Blythe Energy Center Transmission Line Project
Request for Staff Approved Modification
(99-AFC-08T)
Response to Data Request - Revised 2/8/11

TECHNICAL AREA: Transmission System Engineering
AUTHOR: Ajoy Guha

DATA RESPONSES

BLYTHE ENERGY, LLC		JOB NUMBER	REV
BLYTHE - JULIAN HINDS 230KV TRANSMISSION LINE		115210	B
DUCT BANK DETAILS		DRAWING NUMBER	U0-2

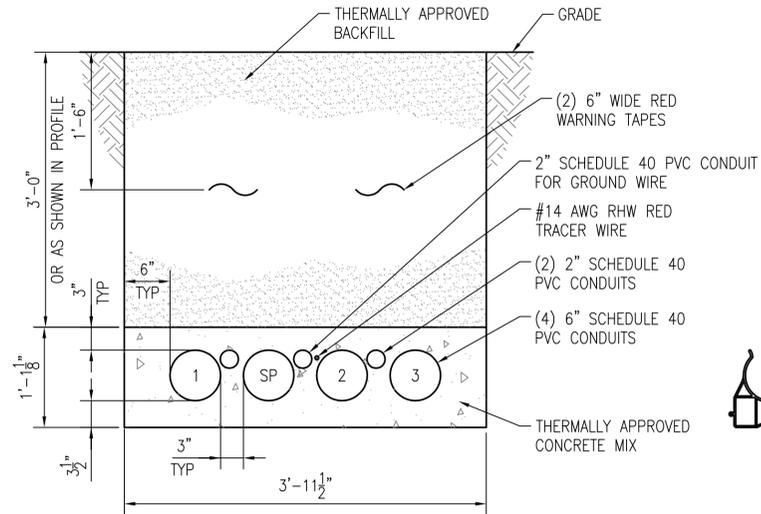
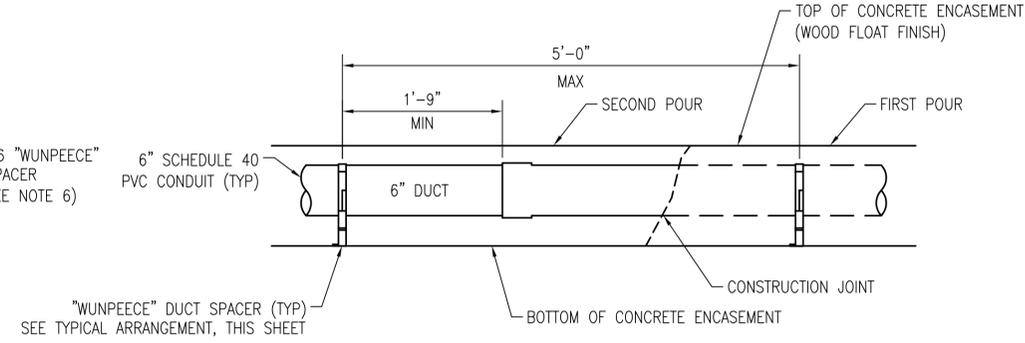
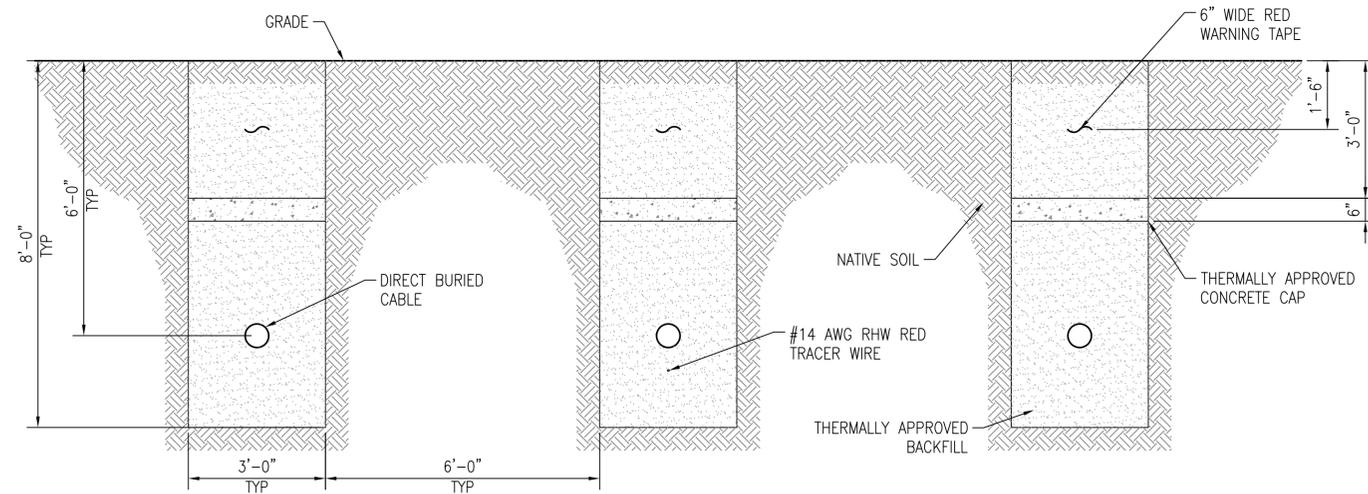
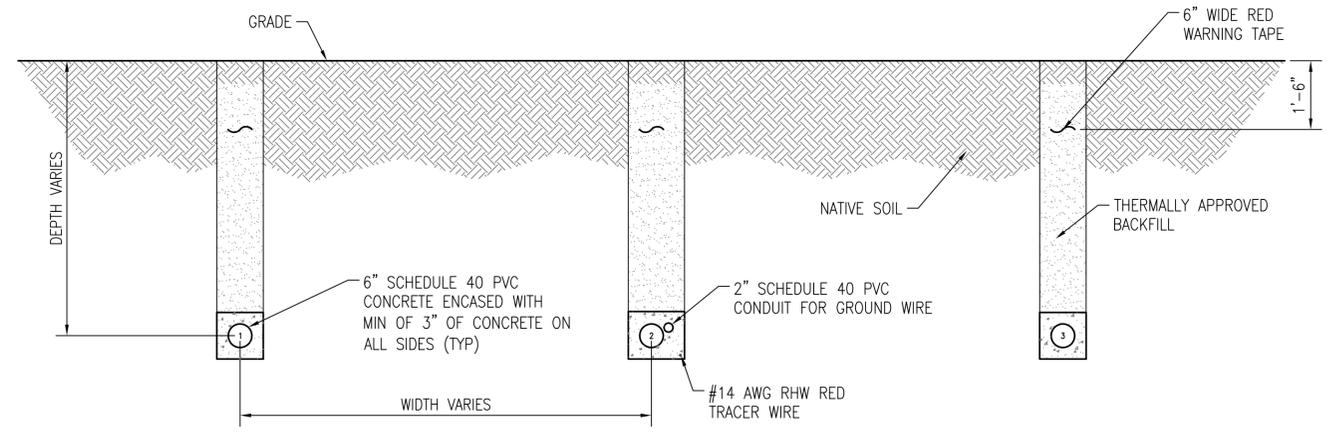
DATA REQUEST 4: Submit a design diagram of Duct Bank construction (or any other type) for the proposed 230 kV underground cable lines (including grounding and communication cables, if applicable). Provide the type, size and ampere rating of the 230 kV underground cables for all transmission outlets including BEP 230 kV line to Julian Hinds.

DATA RESPONSE 4: Please see Figure 5, sheets U0-1 through U0-3, for requested design diagrams of the duct bank construction for the proposed 230kV underground cable lines. The type, size, and ampere ratings are as follows:

For the interconnections from each turbine to the GIS, 1750kcmil copper conductor, carrying 457 amps, will be used. For the interconnection from the GIS to the Blythe-Julian Hinds 230kV transmission line, 5000kcmil copper conductor carrying 2058 amps will be used.

JOB NUMBER	REV
117573	A
DRAWING NUMBER	
E1-3

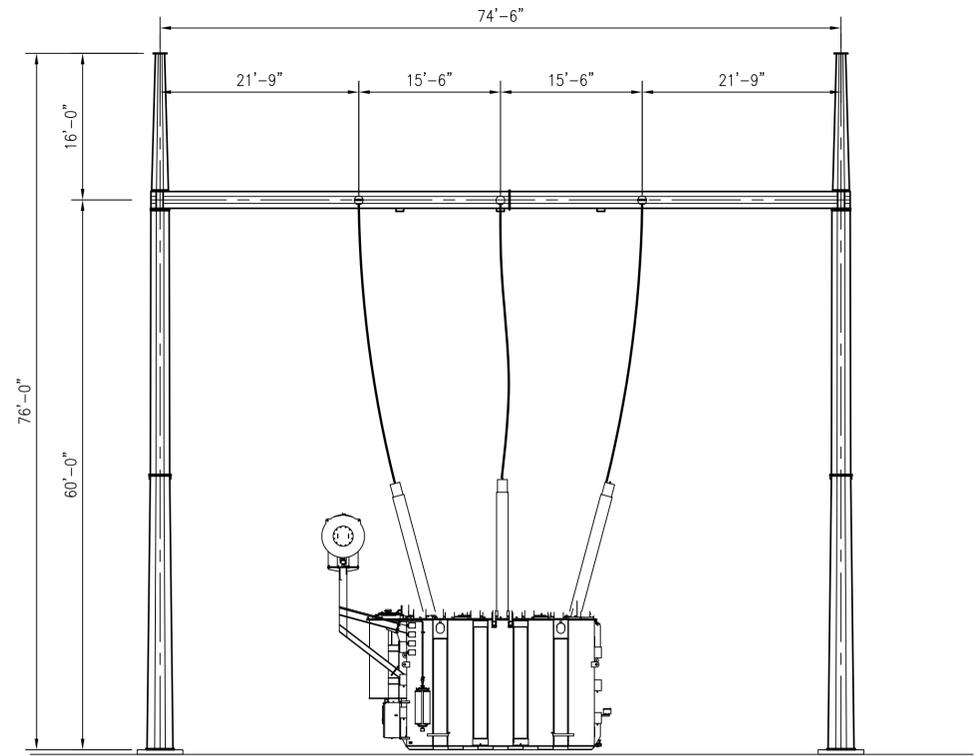
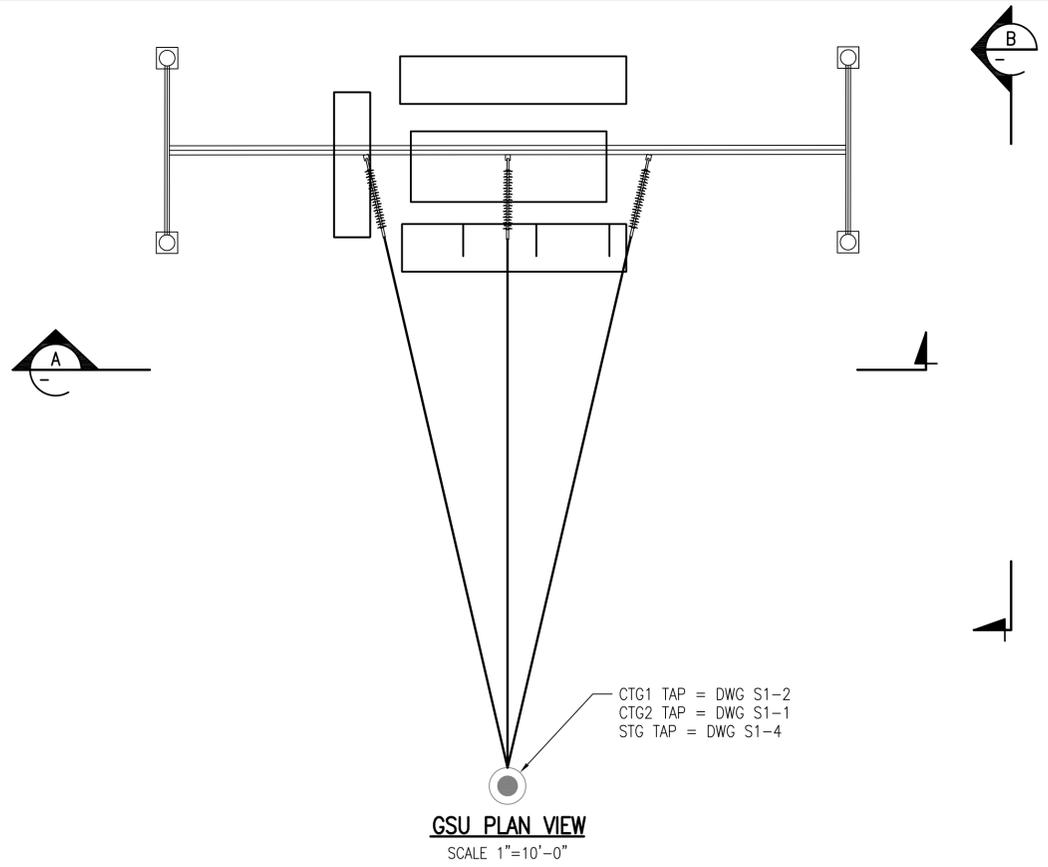
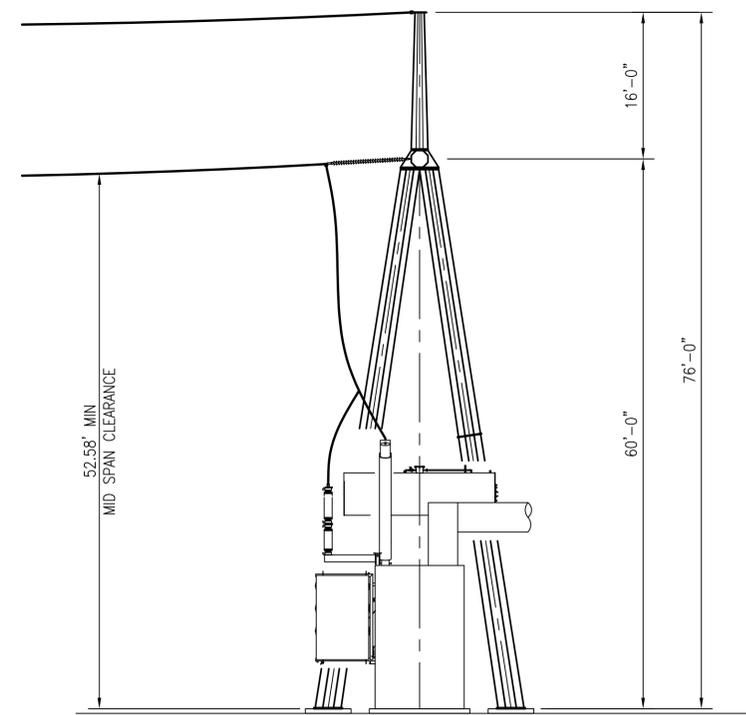
DATA REQUEST 8: Provide detail of the GSU to A-frame taps to show the insulators with spacings on the cross arm and wire connections to the GSU transformers underneath and to the GSU tap structure/pole including ground clearances from the lowest conductor. Provide a side view and plan view of the same showing configuration of the phase wires and insulators with their spacings on the A-frame structure.

DATA RESPONSE 8: Attached please see Figure 6, drawing E1-3 which details the GSU tap configuration for STG-1, CTG-1 and CTG-2. Requested detail and dimensional information has been shown on this drawing.
